HISTORIC AND DESIGN REVIEW COMMISSION

September 07, 2016

HDRC CASE NO: 2016-056
ADDRESS: 112 E PECAN ST
LEGAL DESCRIPTION: NCB: 139 LOT: 15 NATIONAL BANK SUB UNIT-2
ZONING: D RIO-3
CITY COUNCIL DIST.: 1
APPLICANT: Irby Hightower/Alamo Architects
OWNER: Mona Ghawi/Weston Properties, LC
TYPE OF WORK: Signage
REQUEST:

CLIENT:	The Weston	DRWG#:	3022
ADDRESS:	112 E. Pecan St.	SALES REP:	Jeanette M.
CITY:	San Antonio, Texas	DESIGNER:	Kate A.
DATE:	3-9-16	CLIENT APPROVAL:

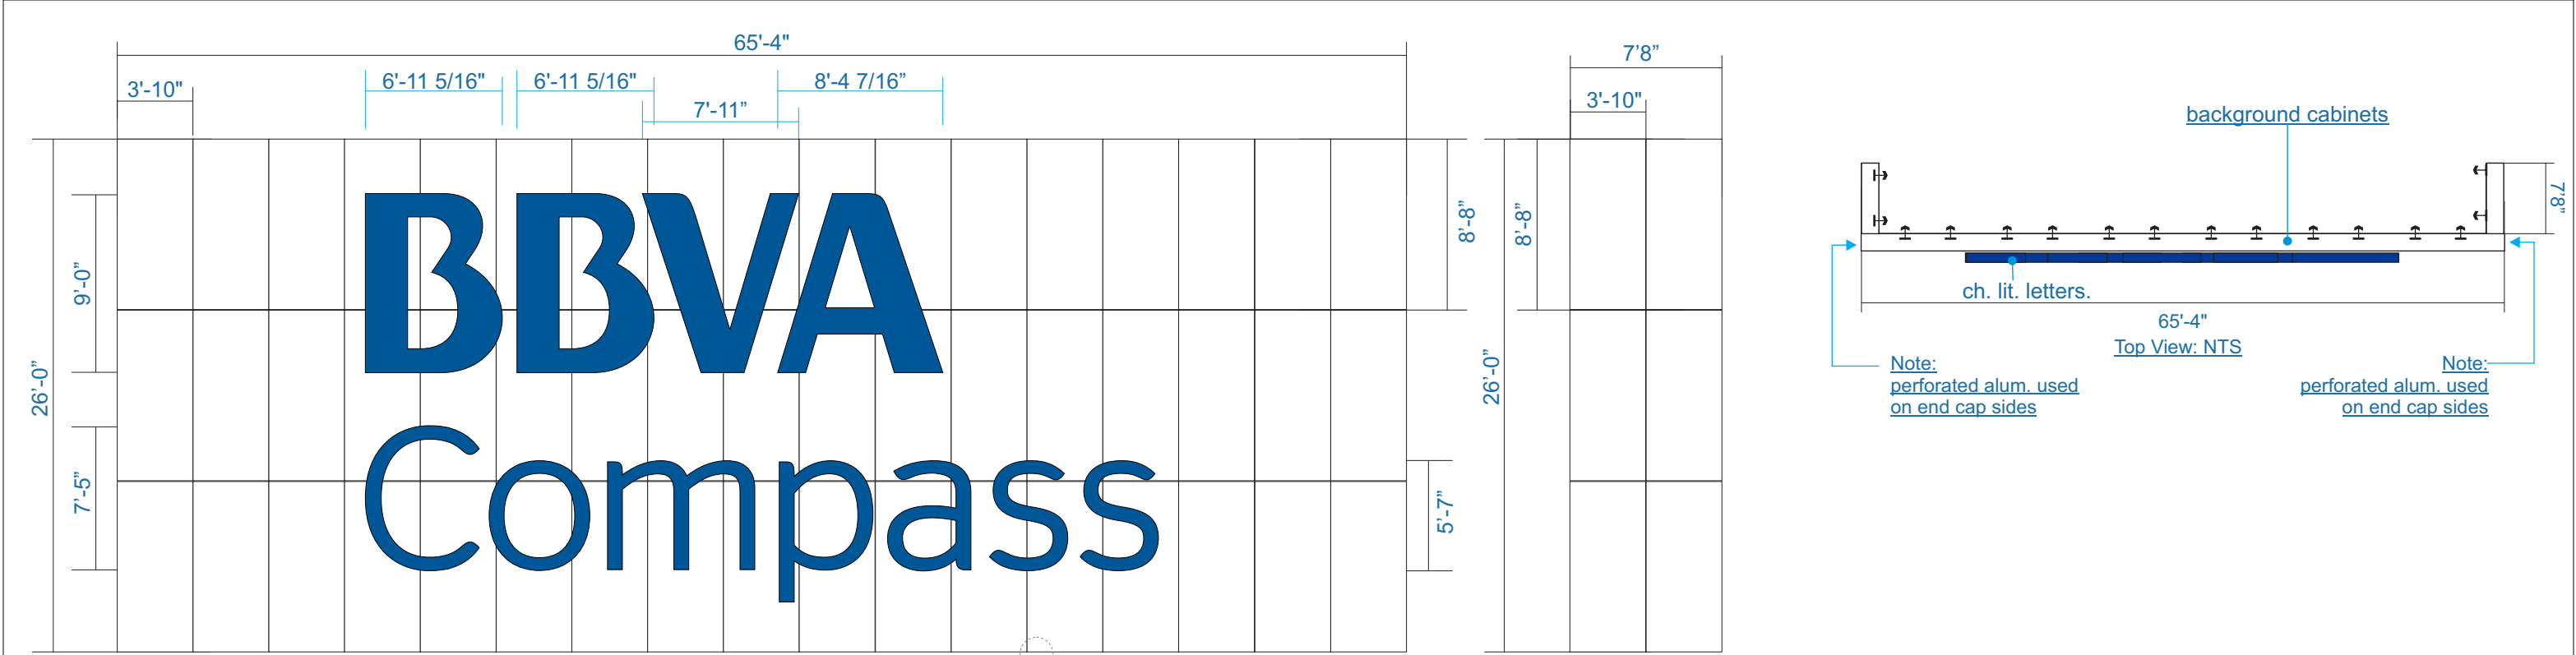
- c. The applicant has proposed to install (1) sign at the entrance facing the intersection of Soledad and Pecan and one (1) sign at the recessed entrance facing the River Walk. Both proposed signs will feature an aluminum backer panel with mounted reverse channel letters featuring aluminum construction and will be illuminated by white LED's. These signs measure 3' – 0" in height and 16' – 9" in length. The entrance at the River Walk is recessed and is not easily visible from the property edge. Per the UDC Section 35-678(c)(4), signage may be illuminated by indirect, internal or bare bulb sources, provided that glare is not produced. In addition to this, applicants may apply for a total of three (3) signs with square footage not exceeding fifty (50) square feet unless that additional square footage is approved by the HDRC. Staff finds this signage appropriate and consistent with the UDC.

Staff recommends approval as submitted based on findings a through g.

CLIENT:	BBVA Compass	DRWG#:	3006.1
ADDRESS:	112 East Pecan St. #175	SALES REP:	Jeanette M.
CITY:	San Antonio, Texas	DESIGNER:	Kate A.
DATE:	2/23/2016	CLIENT APPROVAL:

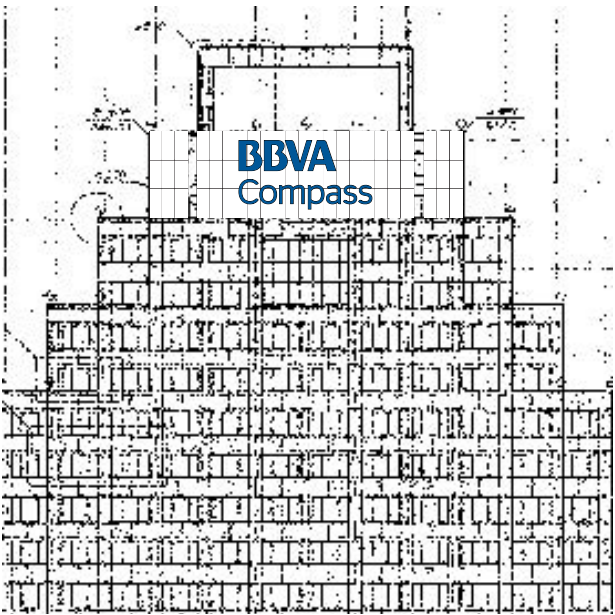
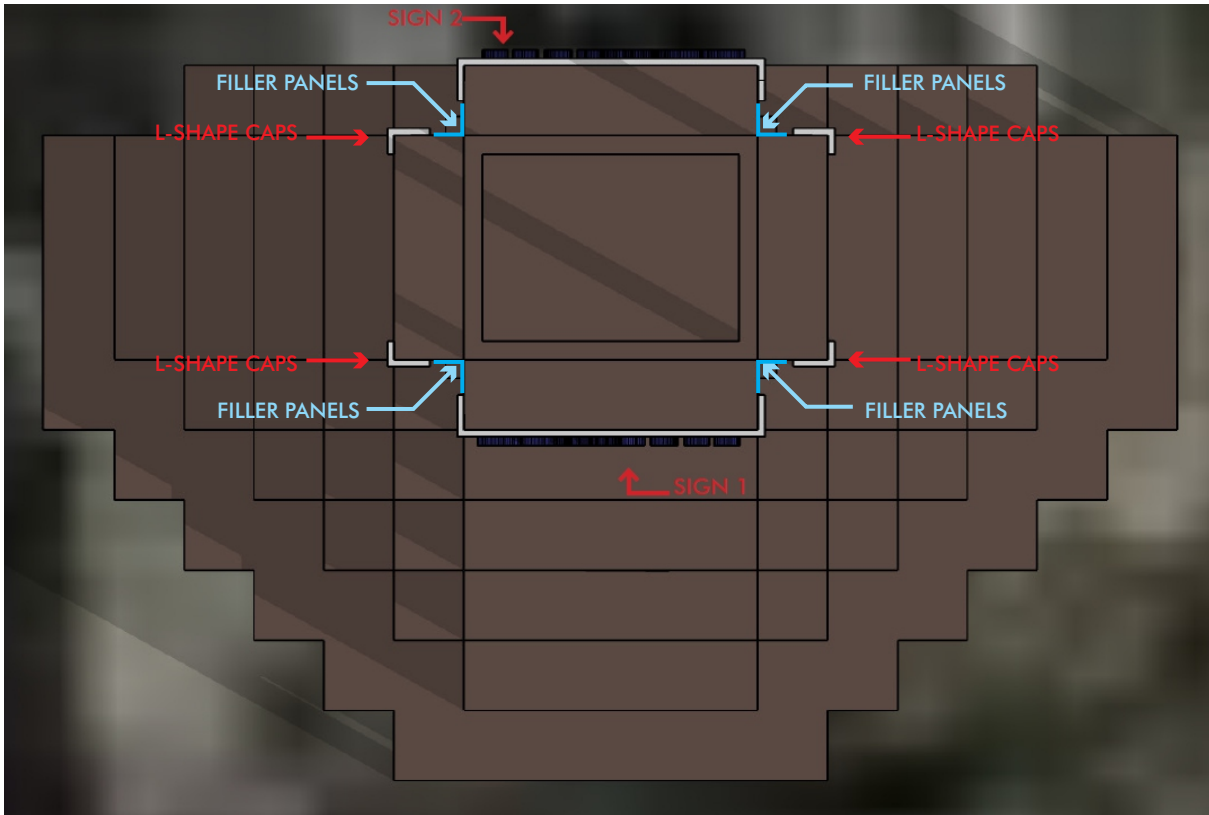
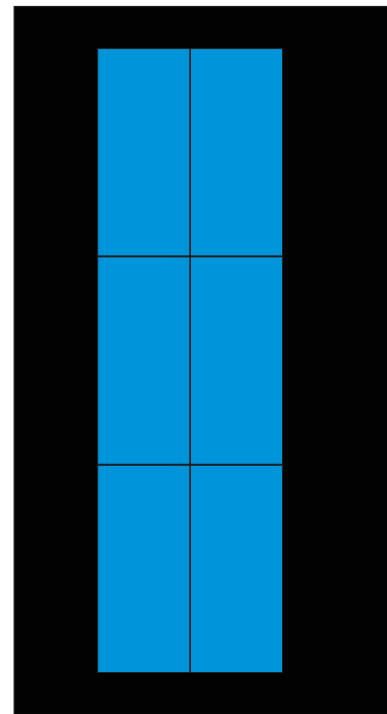
- d. At the capital of the building, the applicant has proposed to install two (2) building signs and four (4) L shaped decorative caps. Both sign panels will be 65' – 4" in length and 26' – 0" in height and will feature two 7' – 8" returns on both sides. The panels will read "BBVA Compass" featuring front lit channel letter with white lexan faces. The proposed letters will span a length of approximately thirty (3) feet with "BBVA" featuring nine (9) feet in height and "Compass" featuring 7' – 5" feet in height. Each letter will be internally lit with white LED's. The proposed L shaped decorative caps will be 26' – 0" in height, 7' – 8" in width and feature a return of 3' – 10" in width. Both panel systems will consist of perforated aluminum panels backed with white lexan and internally illuminated by blue LED's. Given the existing height and contemporary architectural style of the Weston Centre, staff finds this proposal appropriate.

Specifications:
Manufacture and install four (4) alum fillers to cover spandrel glass

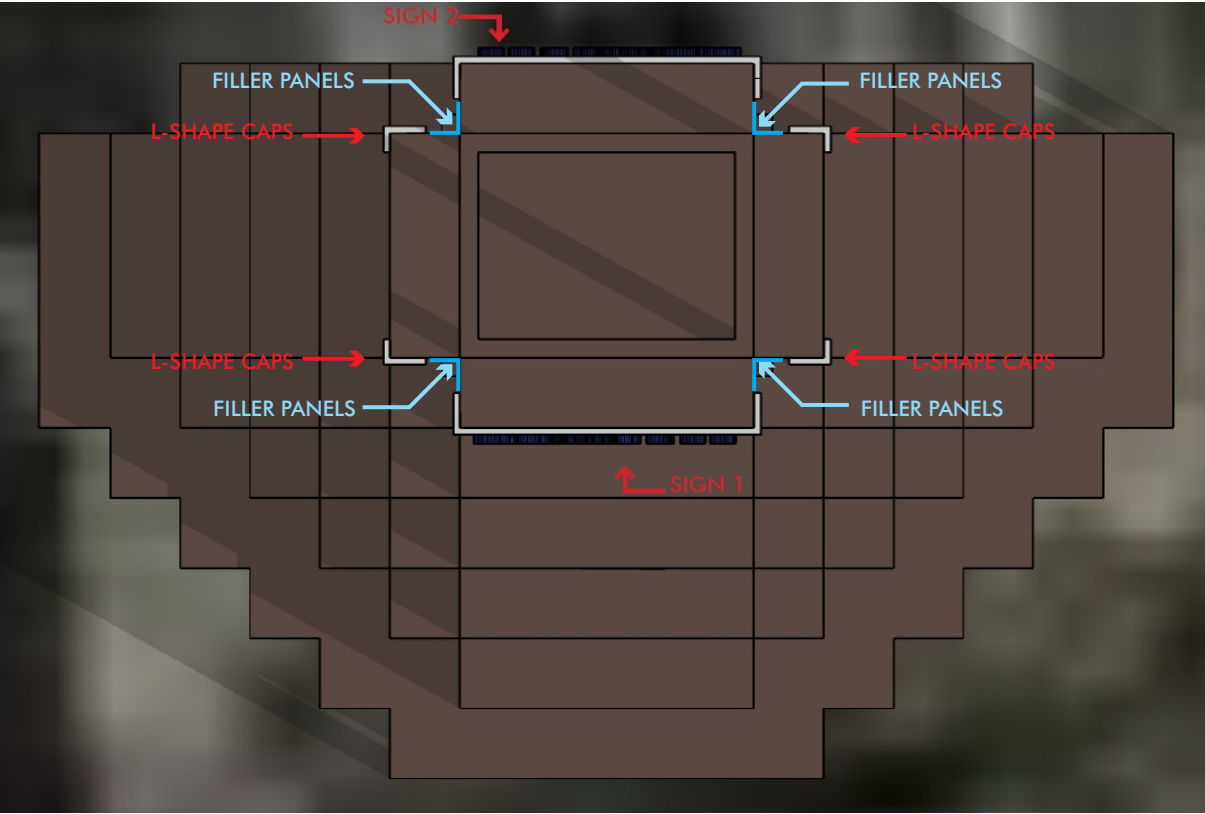
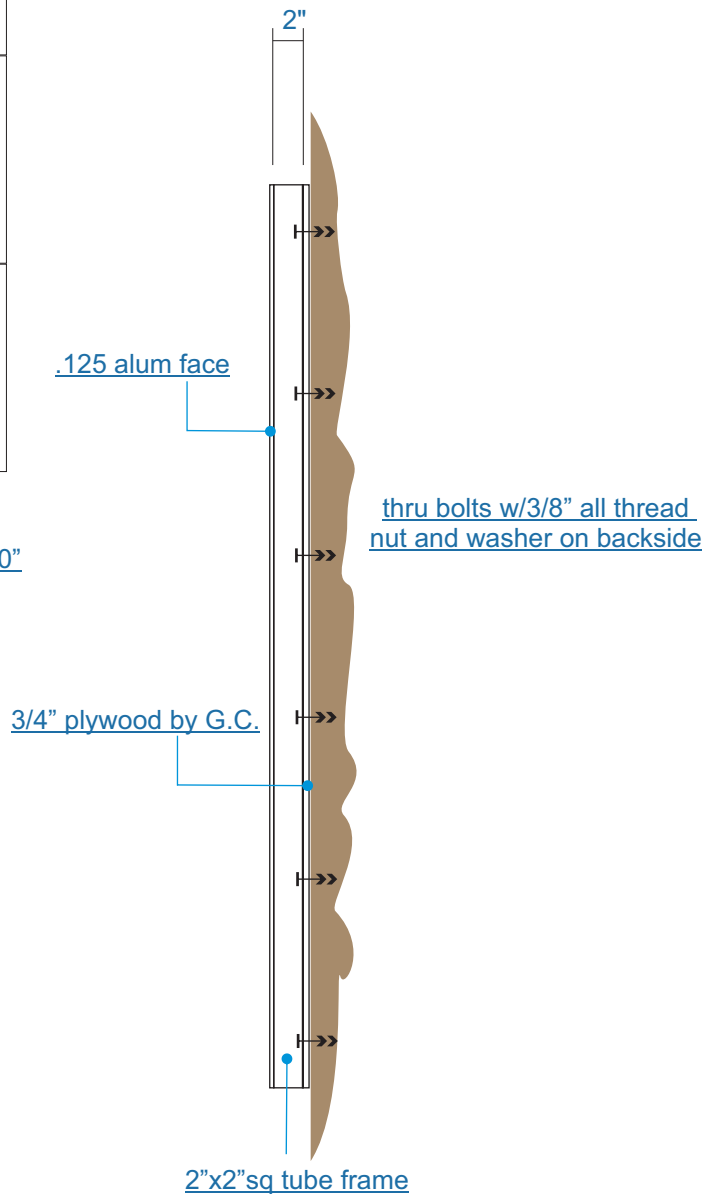
- f. In addition to the signage panels and decorative caps, the applicant has proposed to install four (4) non-lit, aluminum filler panels. The proposed filler panels are to be 26' – 0" in height and feature sides of 8' – 0" and 7' – 4" in width. Staff finds the introduction of these panels appropriate.
